March 3, 2023

Version 2

Product Update: 2022 CR-V EPS Gearbox ReplacementSupersedes 22-011, dated June 15, 2022, to revise the information highlighted in **yellow**.**AFFECTED VEHICLES**

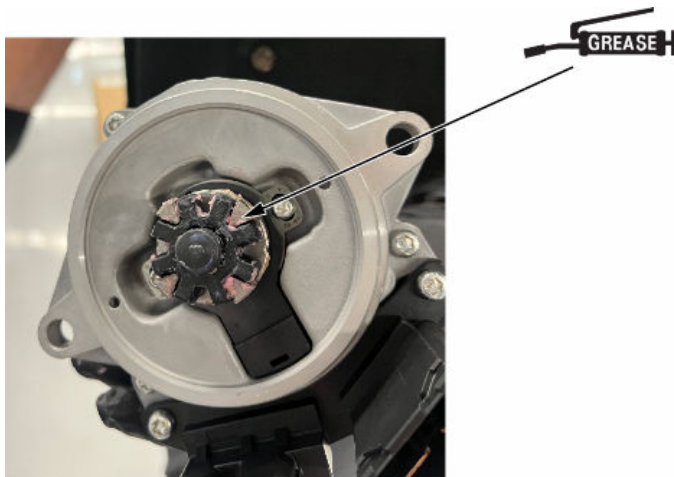
Under REPAIR PROCEDURE, steps 23.2 through 27.5 was added.

23.2. Apply steering grease to the rubber bush and motor bush, then install them to the EPS motor/control unit.
